STATE OF NORTH CAROLINA
DEPARTMENT OF TRANSPORTATION

Subject: Revised Application for Individual Section 404 and 401 Permits and Neuse Riparian Buffer Authorization for the construction of the southern section of Crescent Road from US 70 to US 258 in Lenoir County, west of Kinston. State Project No. 8.2200101. Federal Aid Project Number STP-224(3). TIP No. R-2719A., WBS 34501.1.1.

The purpose of this letter is to provide a revision to the application for a Section 404 Individual Permit, Section 401 Water Quality Certification, and Neuse Riparian Buffer Authorization. In addition to the cover letter this application package includes the following: revised permit drawings, a set of revised half size roadway plans, and a revised mitigation plan.

PLAN VIEW SITE 14

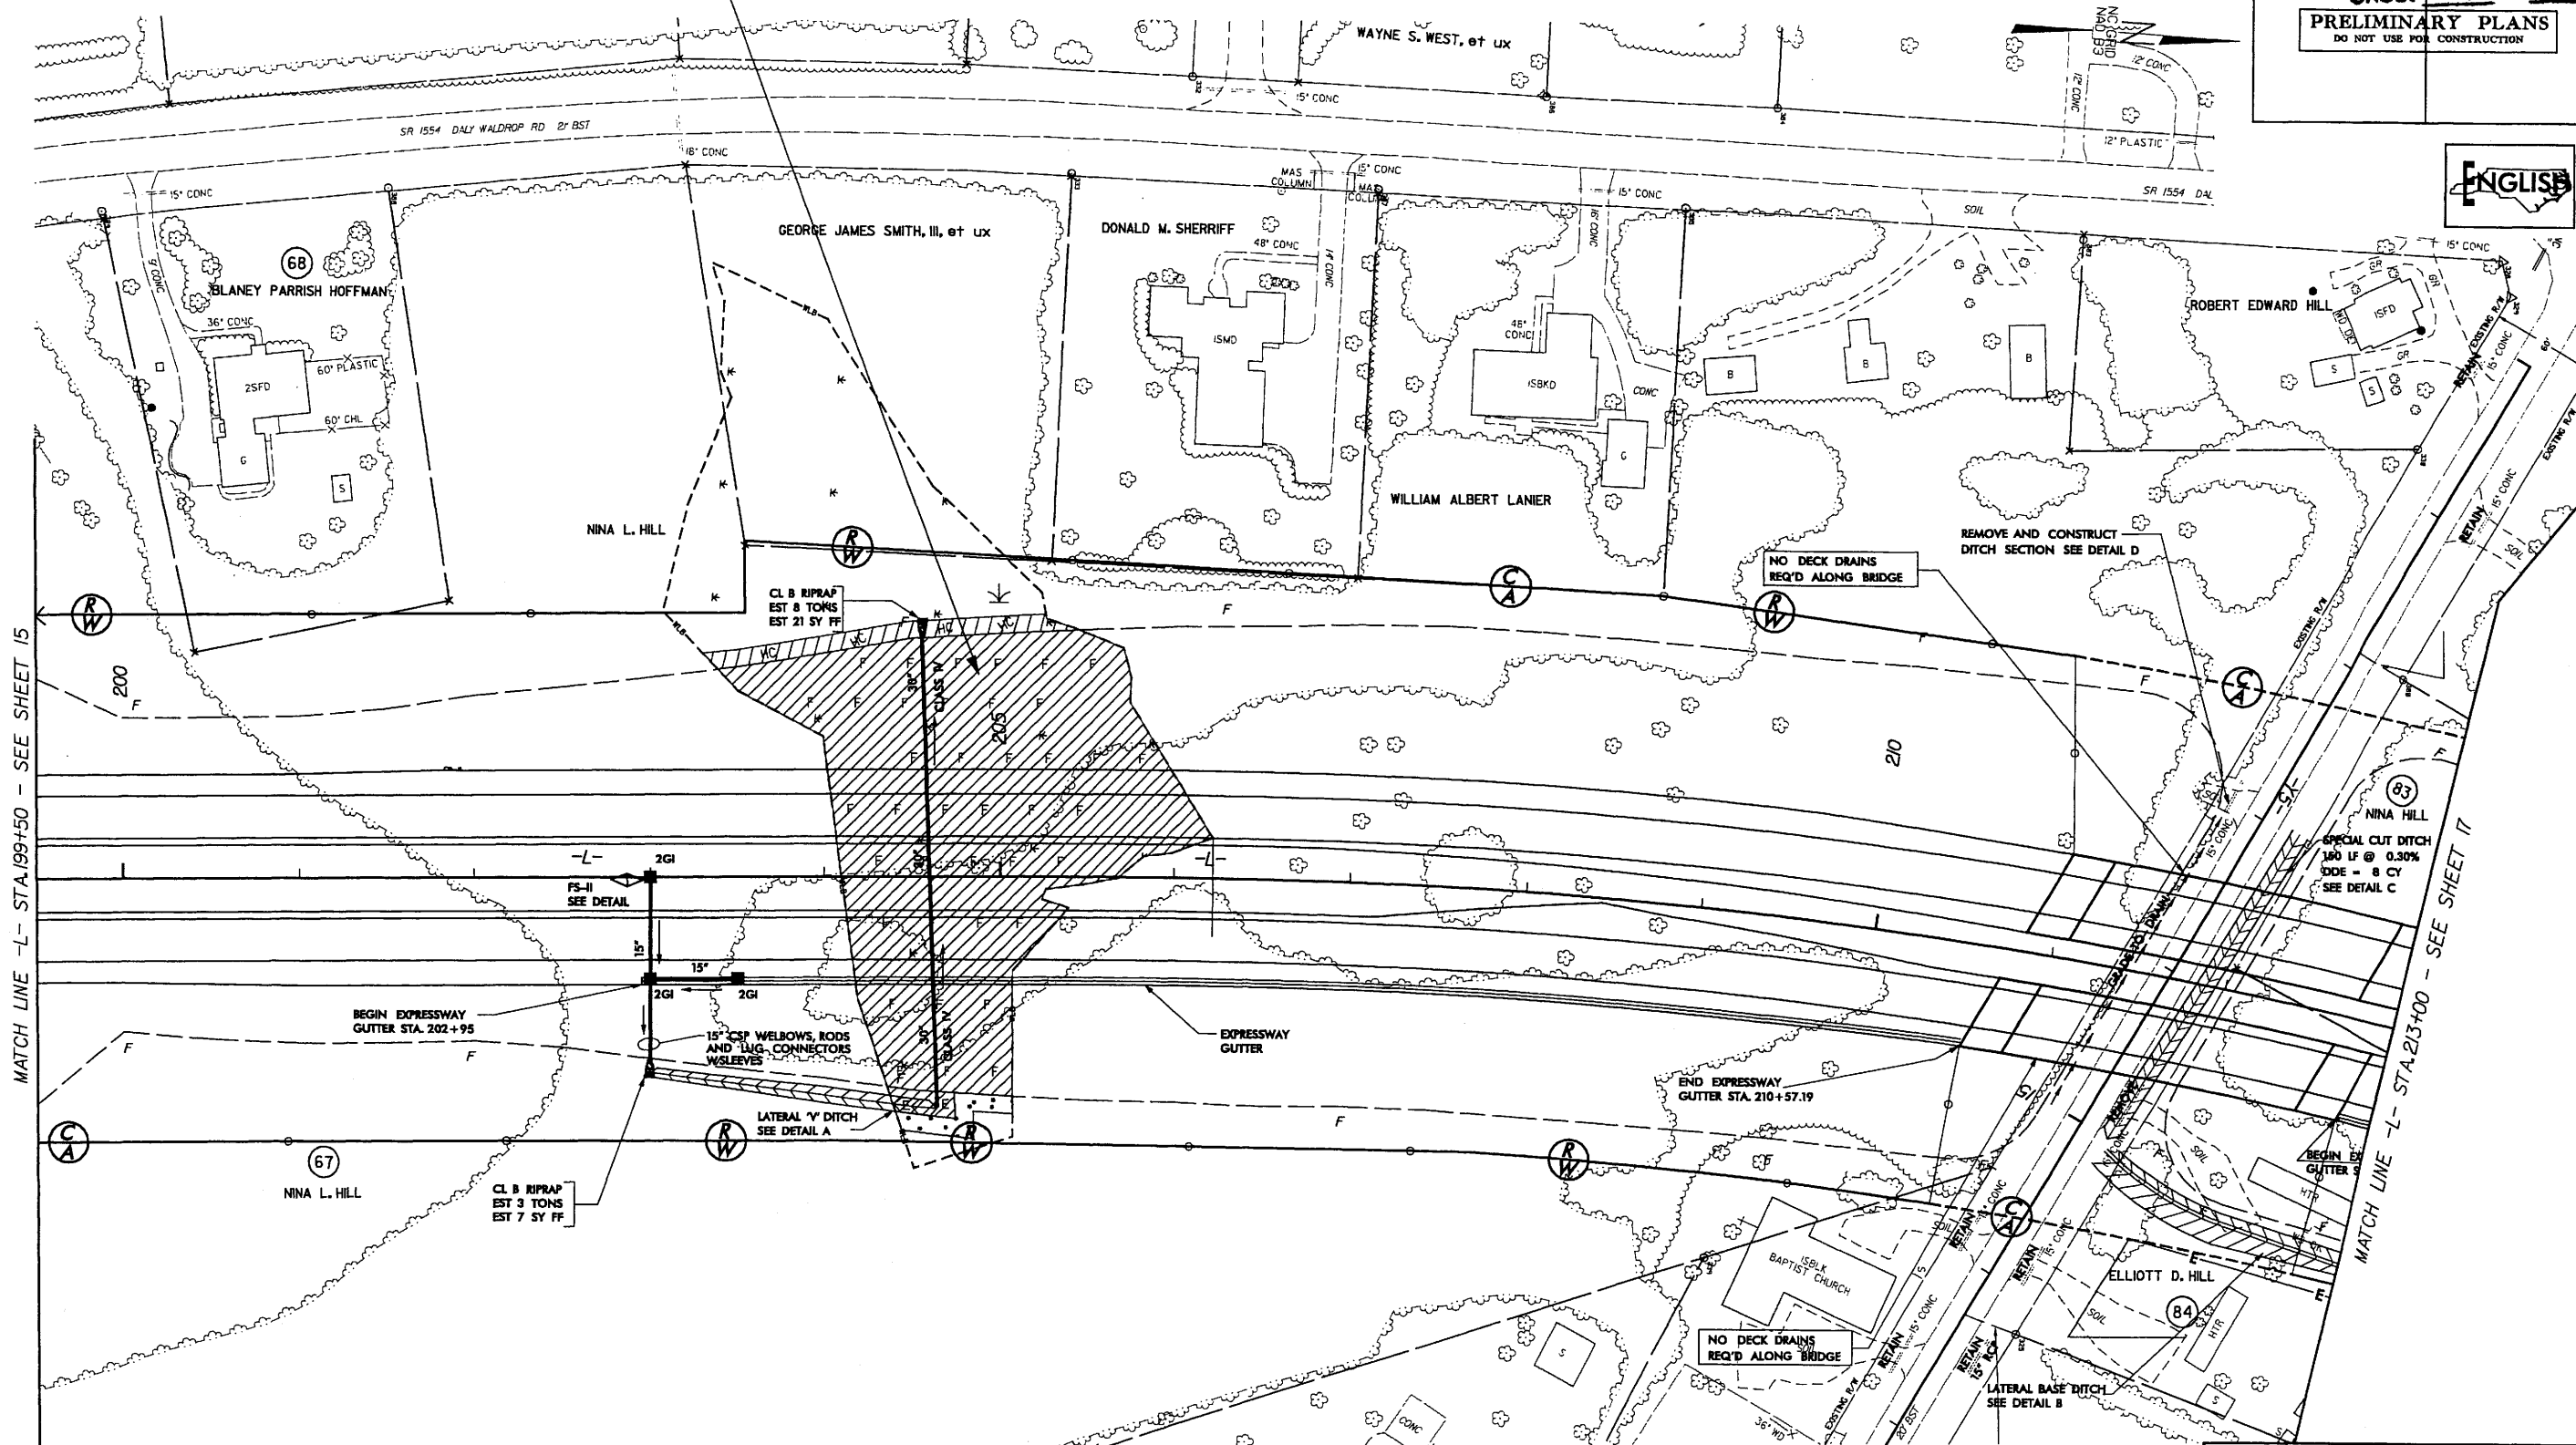
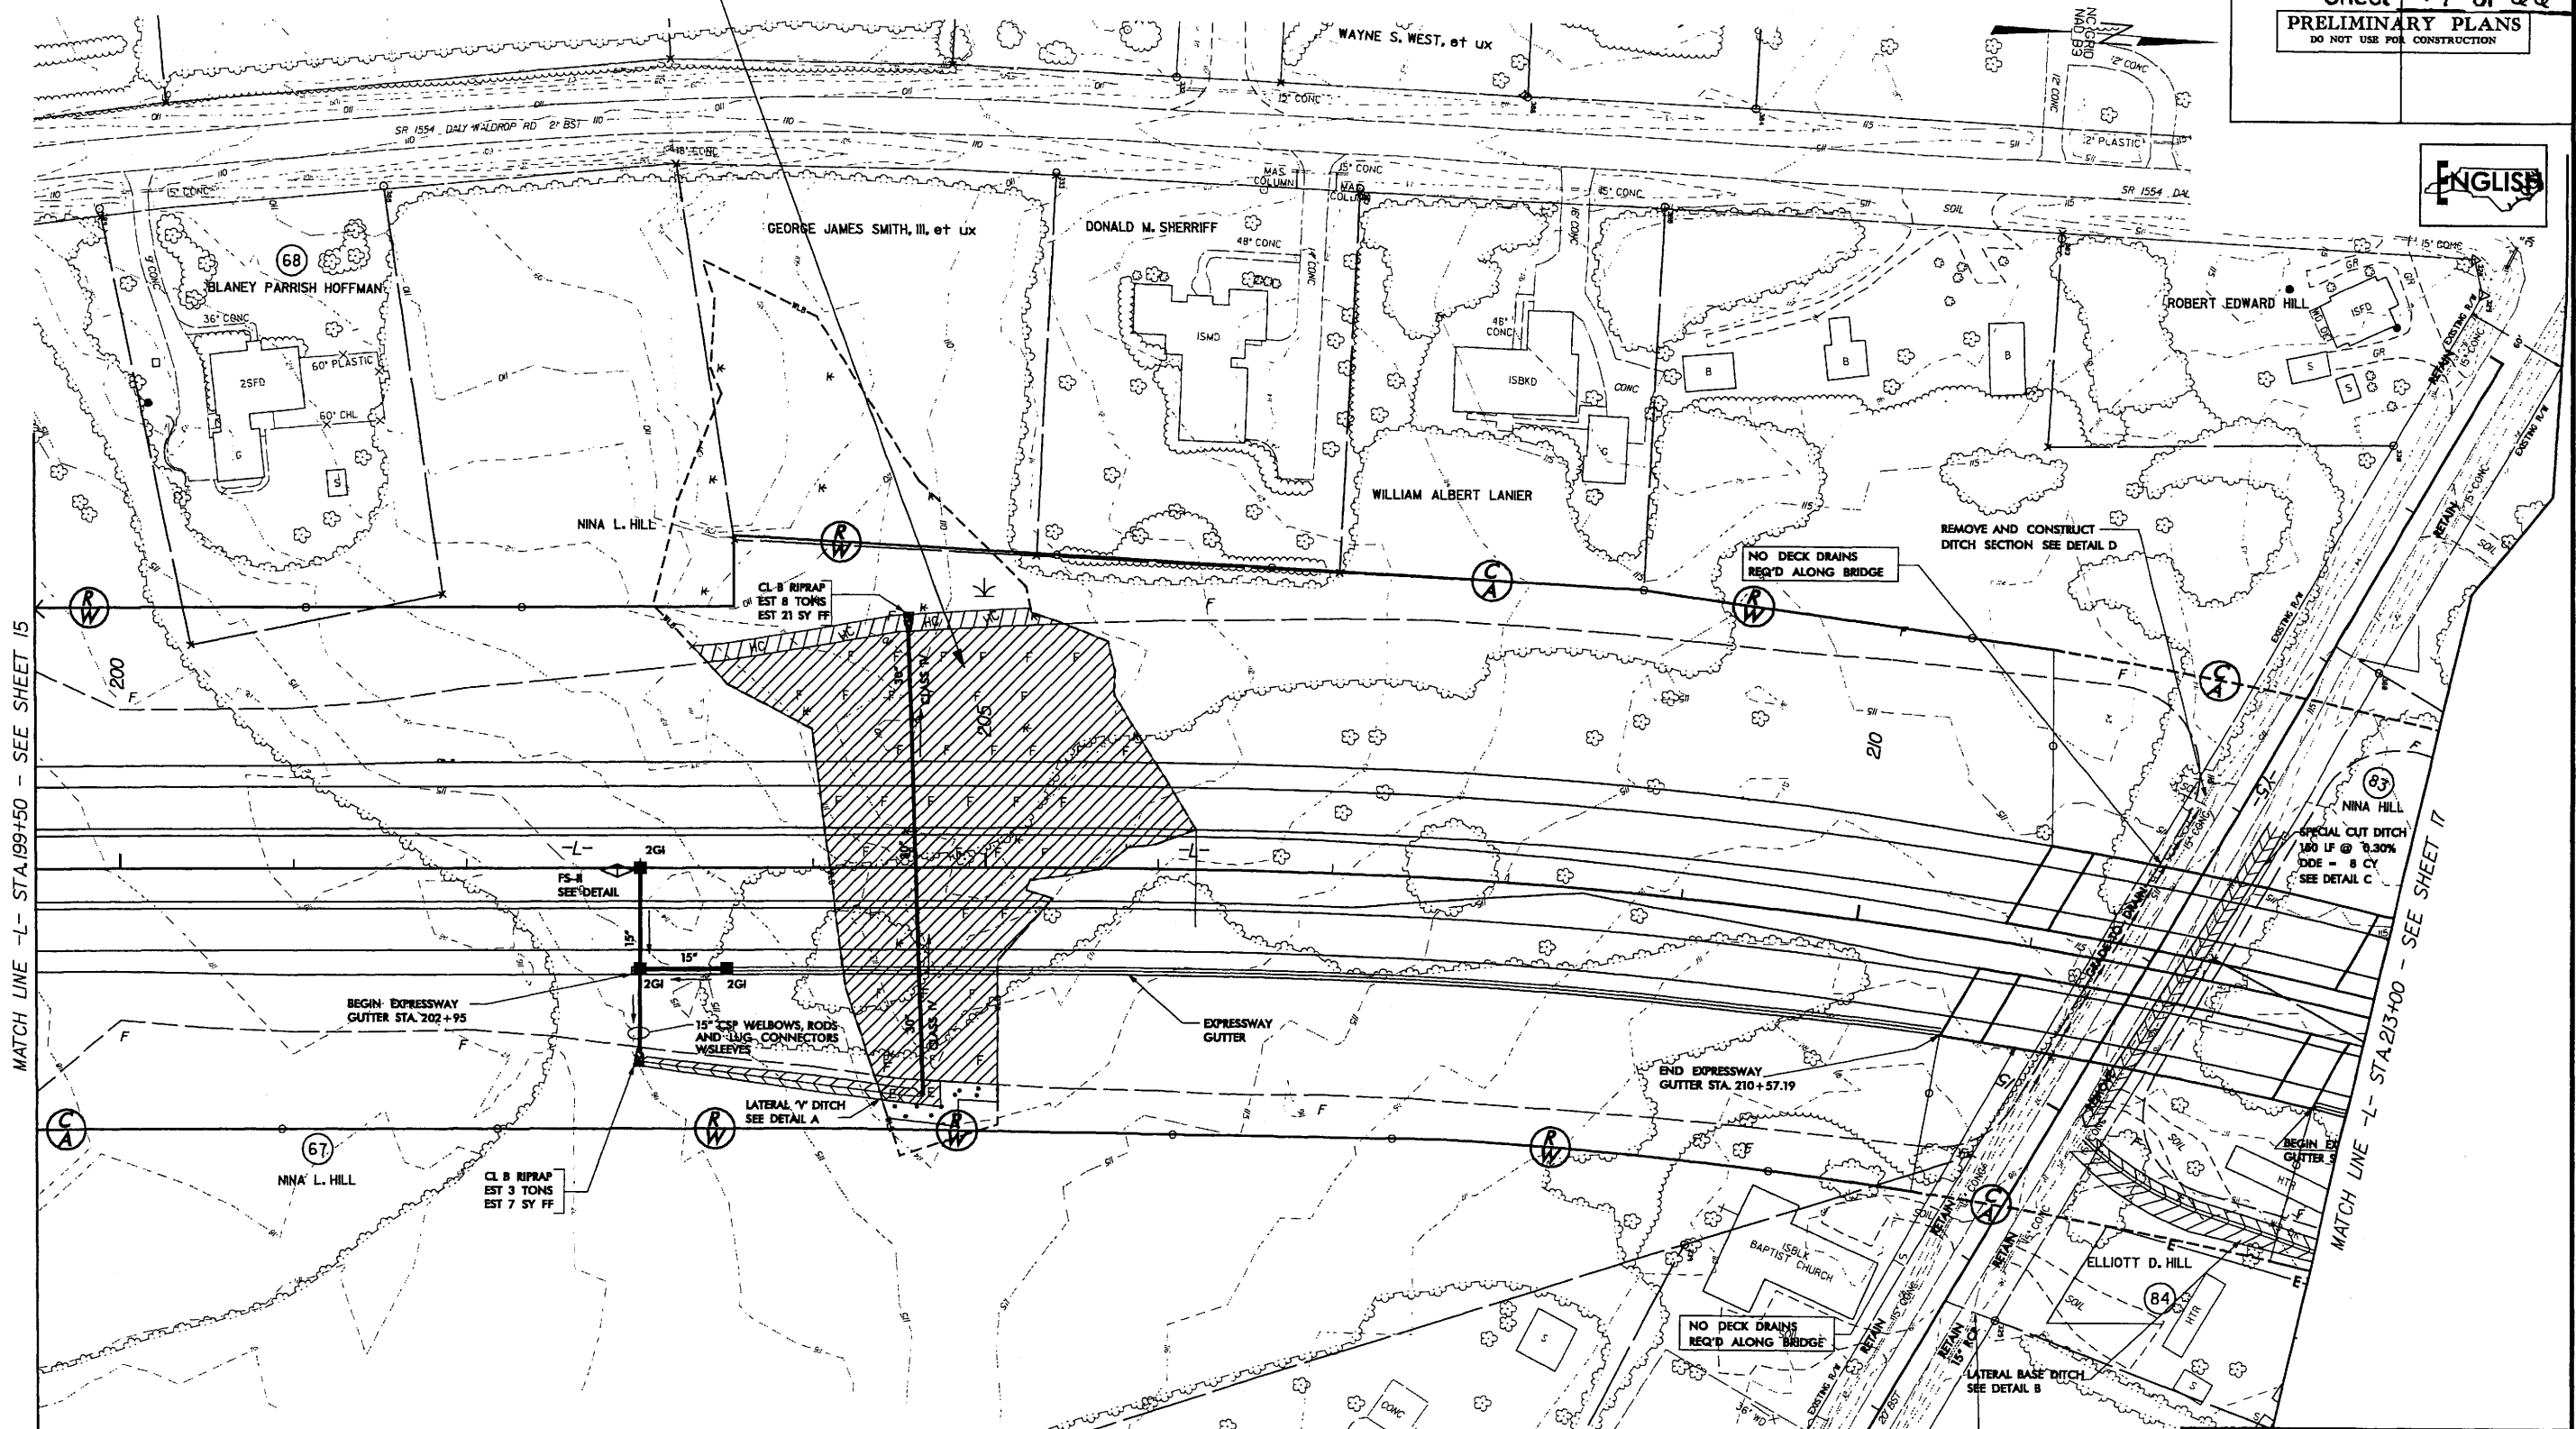
This revision describes the changes in the wetlands impacts due to the outcome of the reverification of the wetlands; also to describe the design change at the railroad crossing. NCDOT redelineated wetlands, due to the expiration of the jurisdictional determination. Several of the wetland lines were shifted as a result of this redelineation. Permit sites 8, 9, 10, 14, and 16 were changed and were verified by William Wescott with the USACE on March 6, 2008.

** The wetland impact to site 14 along right side should be considered as a "total take", and the additional impact area is 0.02 acre. Therefore, the total wetland impact = (0.89+0.01+0.02+0.04)+0.02 = 0.98 acre
